PHILADELPHIA ELECTRIC COMPANY

Subject: Limerick Generating Station, Units 1 and 2 Information for
Containment Systems Branch (CSB) and Accident Evaluation
Branch (AEB) Regarding SGTS Drawdown

In the reference (1) telecon, Mr. Bell of your staff requested that we provide revised FSAR pages which reflect an increase to the reactor enclosure design inleakage rate from 50 to 100 percent free volume per day and a doubling of the SGTS fan flow during drawdown of the Unit 1 reactor enclosure. In response to that request, I am enclosing draft revised FSAR pages.

FIGURE 6.2-52

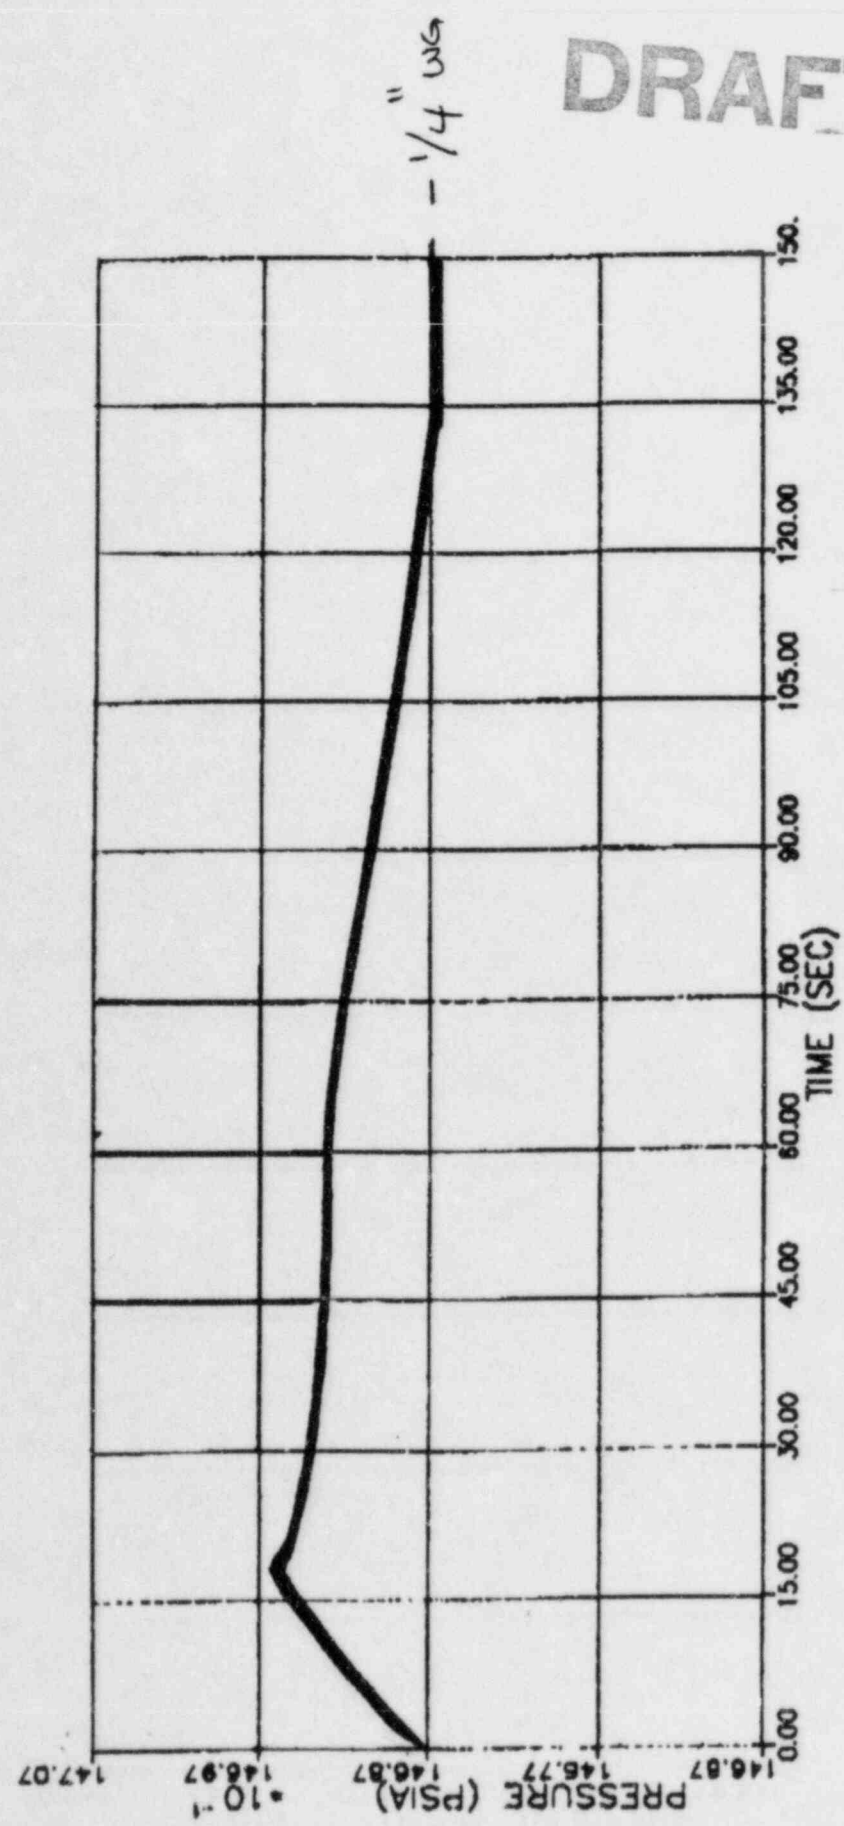
Replace figure
with the attached
